DELEGATED REPORT

APPLICATION REFERENCE: PL/2026/00276
APPLICATION TYPE: Discharge of conditions

SITE ADDRESS: Land at Rowden Park (Phase 5), Patterdown Road, Chippenham, SN15 2NU
PROPOSAL: Condition 9 - PV Panels Condition 10 - Cycle Storage Condition 12 - Visitor Cycle Parking of planning application PL/2025/03847 (Variation of Conditions 3, 9 & Removal of Condition 10 of 20/02335/REM)
RECOMMENDATION: **Partial discharge of conditions.**

Figure 3: Approved layout showing a communal store for apartment block of plots 190-195 with space for at least 6 bikes.

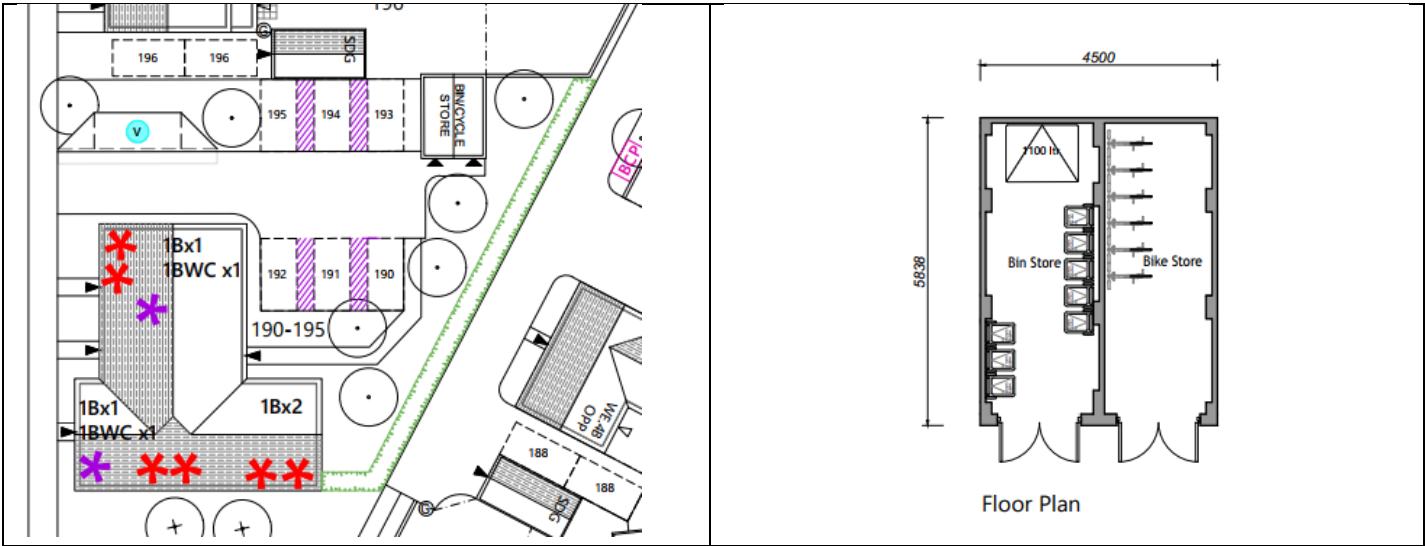
It is also noted that plots 190-195 (6x 1-bedroom apartments) have a different solution which needs to be addressed because it is also not using a garage. Strict interpretation of the condition therefore requires further details of on-plot solutions. However, on the approved plans these plots are shown to have a communal store that can accommodate the required cycle parking to meet LTP3 standards. As such, no further details have been sought and the previously approved information is adequate.
